# The Retreat @ TimberRidge

## Letter of Intent

April 2017

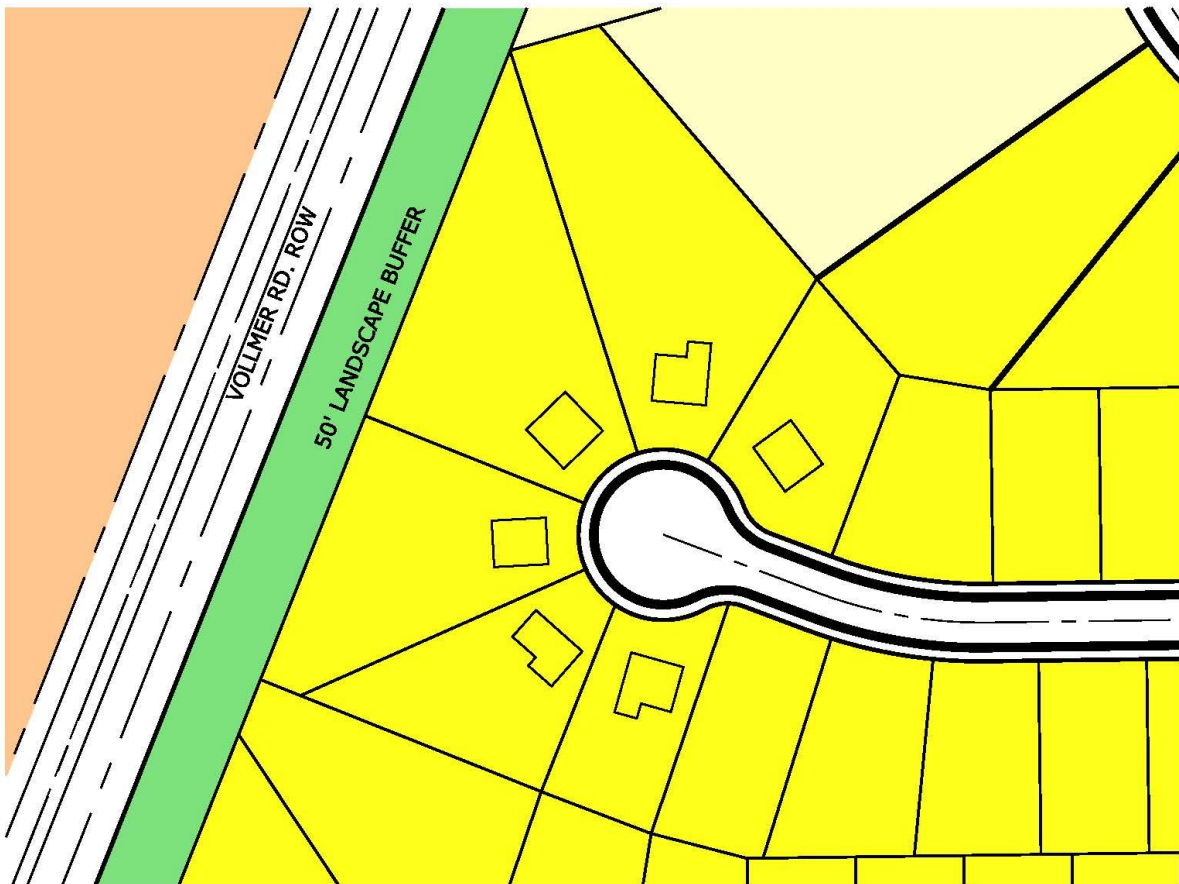
What is the percent of planned open space not to be developed?

Cul-de-Sac "fans" homes and creates larger lots

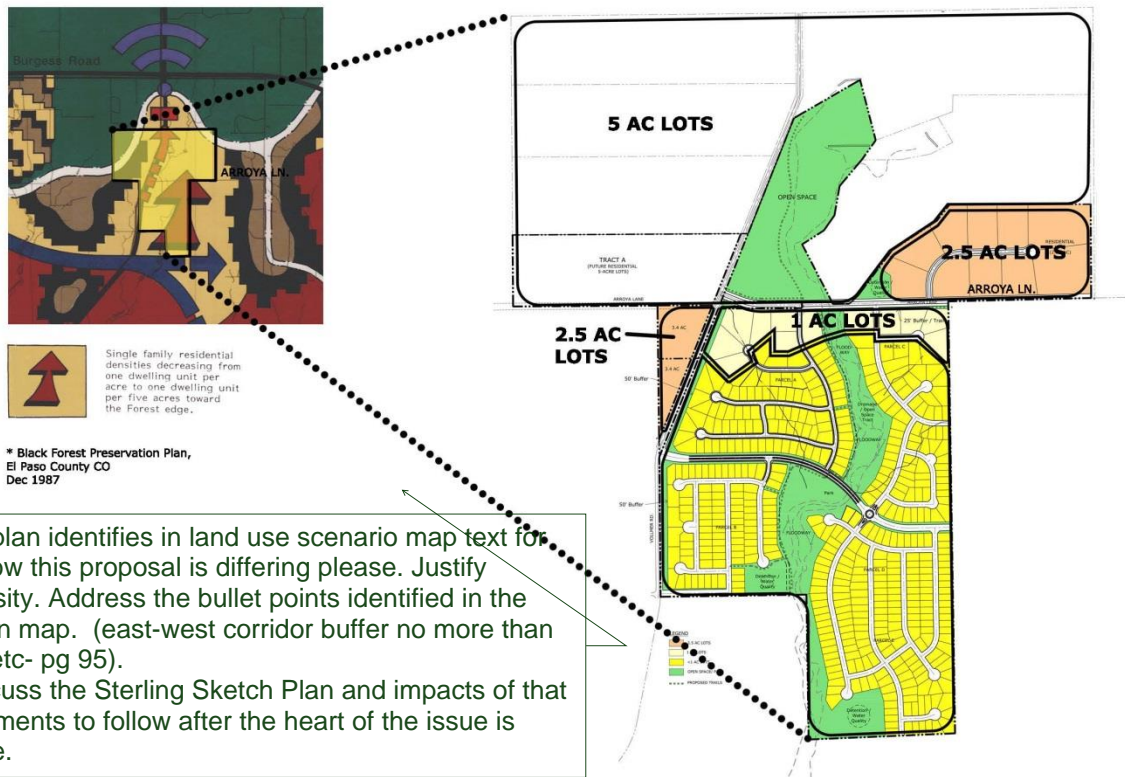
Should address textual content of subarea10

State what the plan identifies in land use scenario map text for this area and how this proposal is differing please. Justify changes in density. Address the bullet points identified in the sub area 10 plan map. (east-west corridor buffer no more than 1/4 mile north, etc- pg 95). Should you discuss the Sterling Sketch Plan and impacts of that approval? Comments to follow after the heart of the issue is addressed more.
